To: Development Permit Panel

File: DP 14-676613

Re: **Application by Ryan Cowell on behalf of 0737974 B.C. Ltd. for a Development Permit at 5600 Parkwood Crescent**

**LANDSCAPE PLAN**

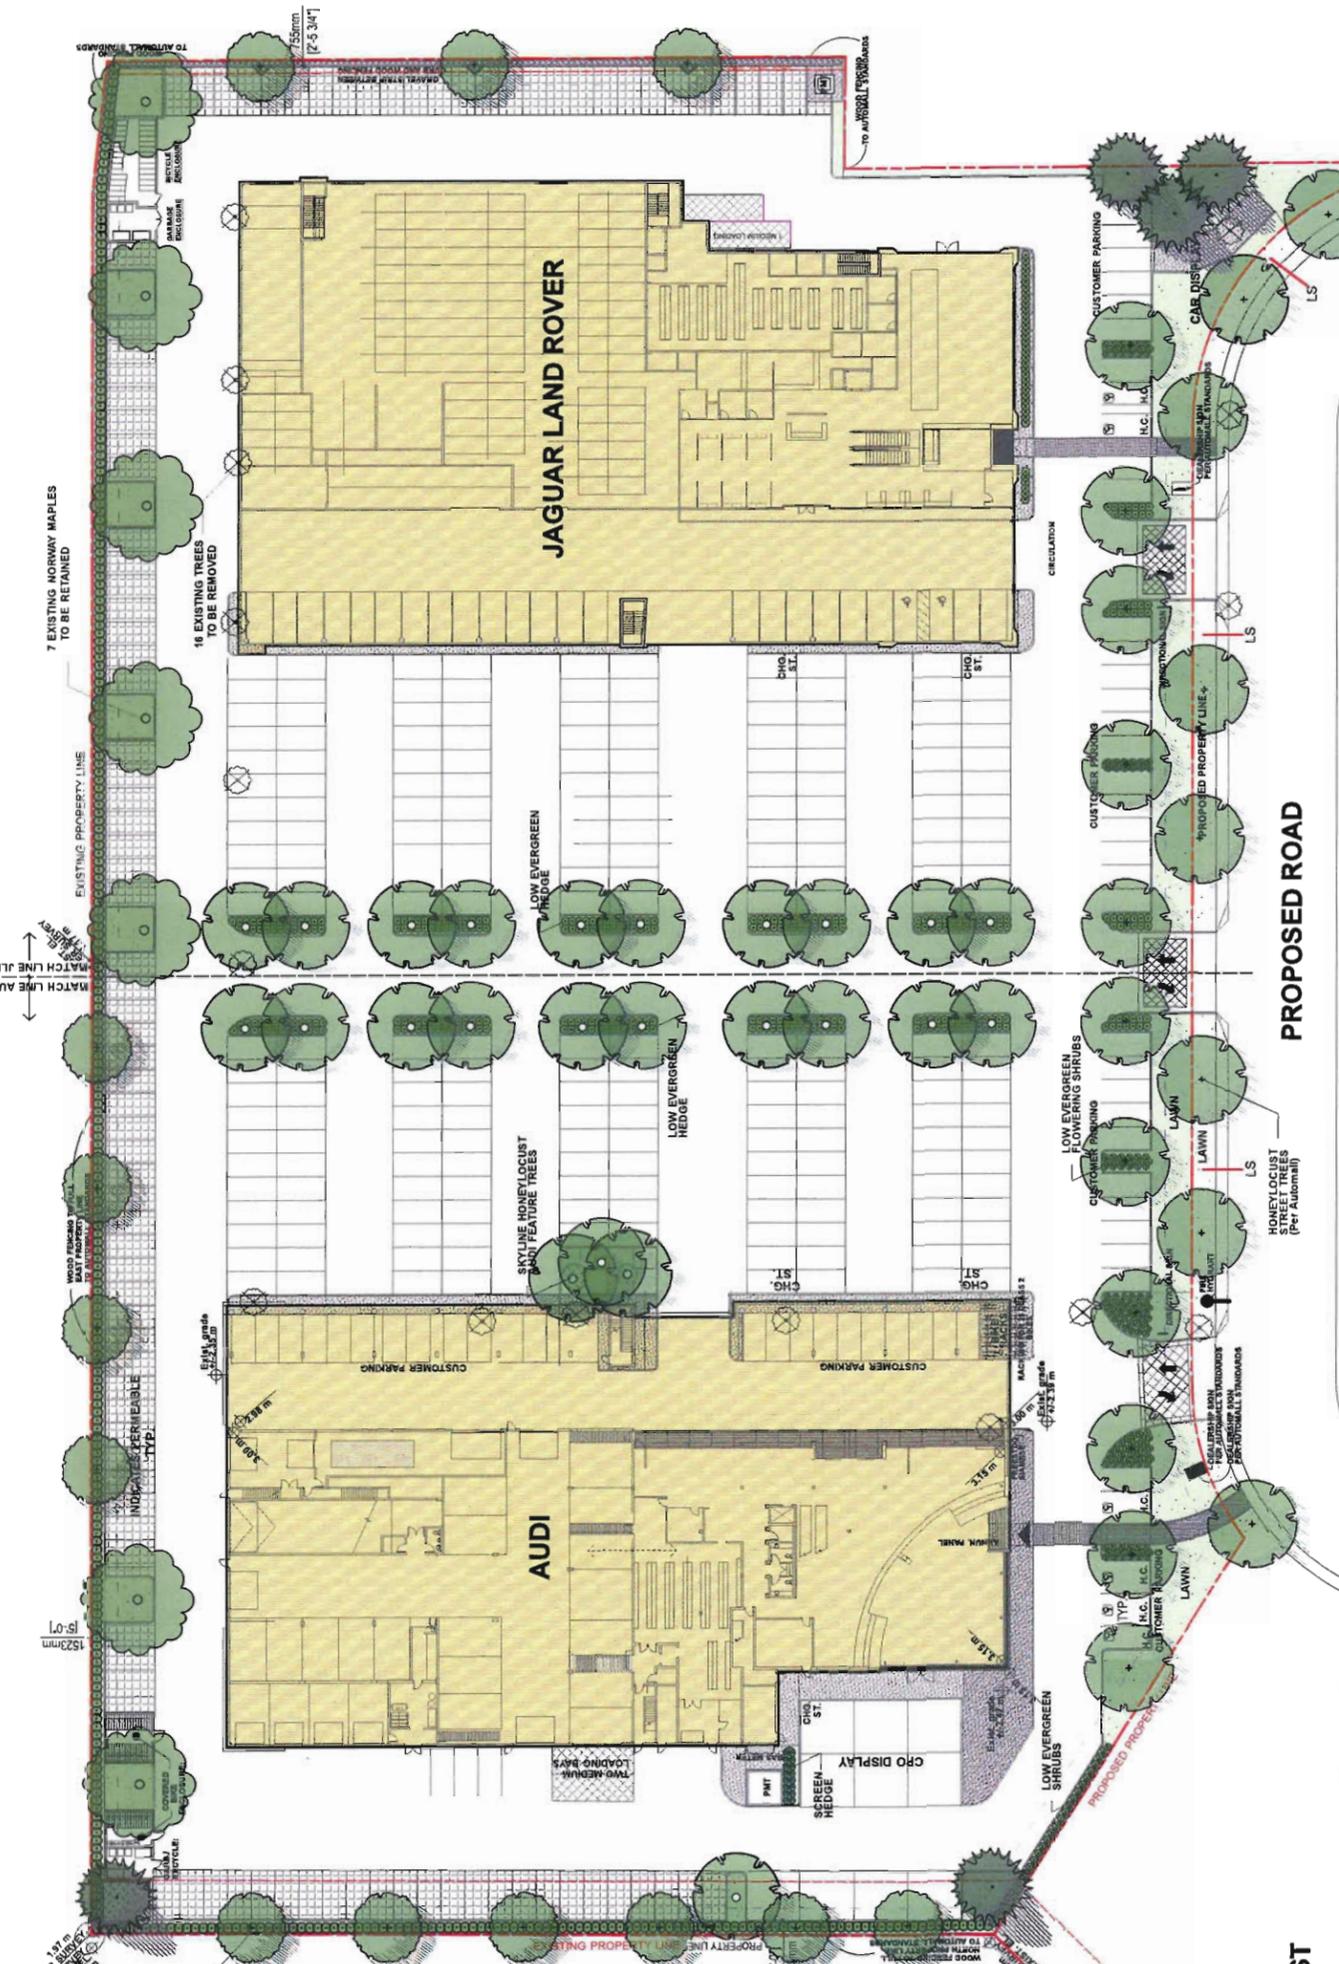
- consider additional row of planting at the centre of the proposed development to mitigate the harshness of the vast hard surface area of the proposed development;

- agree with the comment to add another row of tree planting at the centre of the proposed development to provide more shading and enhance the pedestrian experience;

*Please consider that the drawings and model did not fully convey the planting on this project. The species Honey Locust will reach a much more ample 'canopy' at maturity/within 10 years, and plantings along the new street and of the east-west lane will be a fully shaded coverage. The landscape plan has been updated with accurate canopy of approximately 33' diameter. This will create continuous massing of shade and green which will be a very lush effect. There is also a photograph included on that sheet of an actual mature honey locust of the current Automall plantings, as a visual example.*

***See our comments above regarding the true effect of the mature planting of all the site trees.***
